CLIENT	ZANCOR HOMES
PROJECT/LOCATION	KING CITY KING CITY, ONTARIO
DRAWING	SITE GRADING PLAN
BUILDING STATISTICS	
REG. PLAN NO.	65M-4295
ZONE	R4
LOT NUMBER	5
LOT AREA(m) <sup>2</sup>	N/A
BLDG AREA(m) <sup>2</sup>	N/A
LOT COVERAGE(%)	N/A
NO. OF STOREYS	2
MEAN HEIGHT(m)	8.19
PEAK HEIGHT(m)	N/A
DECK LINE(m)	N/A

APPROVED FOR GRADING

Reviewed by *[Signature]* R.J. Burnside & Associates Limited  
Date: MAY 08 2012

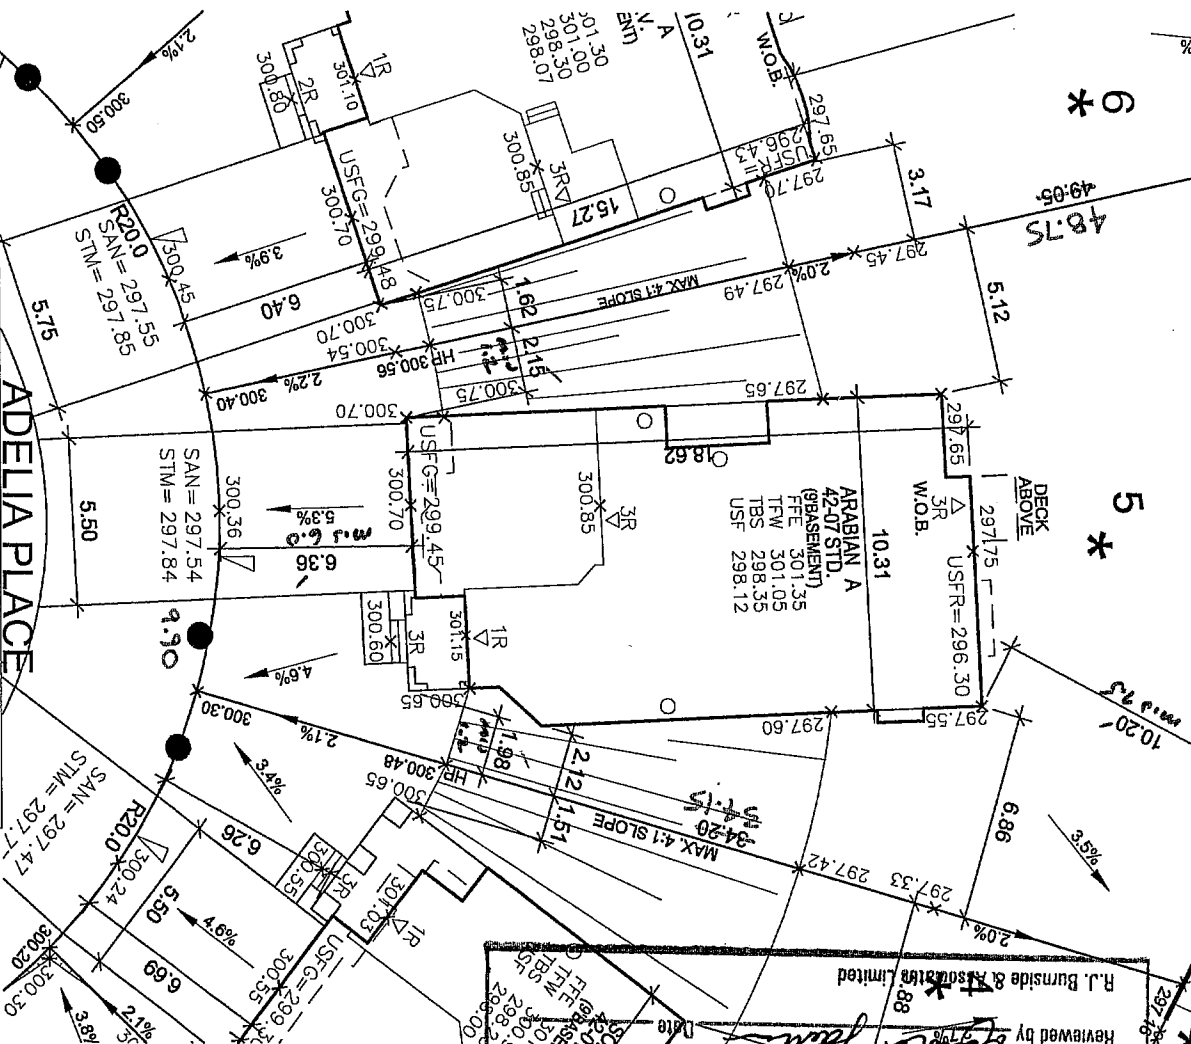
NOTES:  
- Builder to verify storm and sanitary service lateral elevations prior to pouring footings  
- Extend footings at front to ensure 1.25M cover (Min)  
- Garage footings to extend to original ground or as directed by soils engineer.

☒ Reviewed as noted  
☐ Accepted without changes  
☐ Dimensions provided by others
